Access Compliance Report

Public Rights-of-Way

(Curb Ramps)

Intersection ID: 49929	Main Street: ASHBOURNE_HALL_RD	Cross Street: CHAMBERLIN_RD	Location: NE
ADA ID: CE2CB03176D0	Ramp Type: Perp	Initial Pass/Fail: Fail	Overall Compliance: No
		Severity Score: 12.5

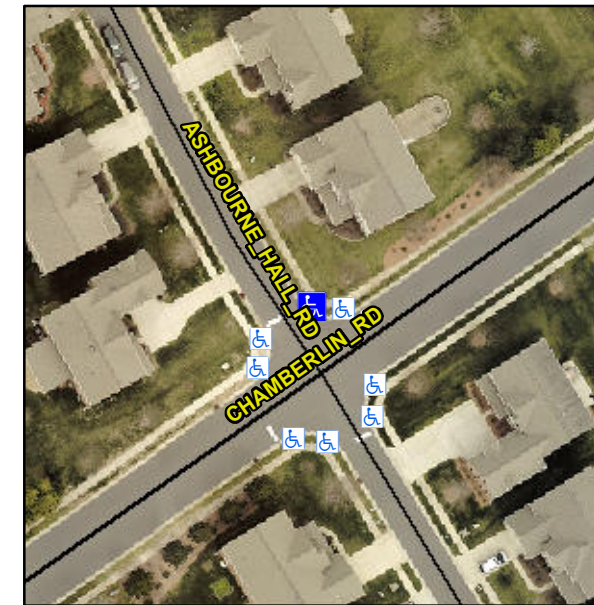
Not Found, R304.5.3

Compliance	Description	Data	Compliance	Description	Data
N/A	Ramp Length (in)	45.0	Yes	Ramp Slope (%)	6.9
Yes	Ramp Width (in)	48.0	No	Ramp XSlope (%)	5.7
N/A	Flare Type LT	N/A	N/A	Flare Type RT	N/A
N/A	Flare Slope LT (%)	N/A	N/A	Flare Slope RT (%)	N/A
N/A	Flare Traversable LT?	N/A	N/A	Flare Traversable RT?	N/A
N/A	Landing Length (in)	N/A	N/A	DWS Provided?	N/A
N/A	Landing Width (in)	N/A	N/A	DWS Contrast?	N/A
N/A	Landing Slope (%)	N/A	N/A	DWS Length (in)	N/A
N/A	Landing X Slope (%)	N/A	N/A	DWS Full Width?	N/A
N/A	Landing Curb? (Y/N)	N/A	N/A	DWS Offset (in)	N/A
N/A	Shared Landing?	N/A			
N/A	Gutter Ponding?	N/A	N/A	Gutter Slope (%)	N/A
N/A	Gutter Lip Ht (in)	N/A	N/A	Gutter X Slope (%)	N/A
N/A	Painted X Walk1?	No	N/A	Painted X Walk2?	N/A
	X Walk 1 Direction	To SW		X Walk 2 Direction	N/A
N/A	X Walk 1 Width (in)	N/A	N/A	X Walk 2 Width (in)	N/A
	X Walk 1 Slope (%)	3.9		X Walk 2 Slope (%)	N/A
	X Walk 1 X Slope (%)	2.4		X Walk 2 X Slope (%)	N/A

Remove & Replace Entire Ramp.
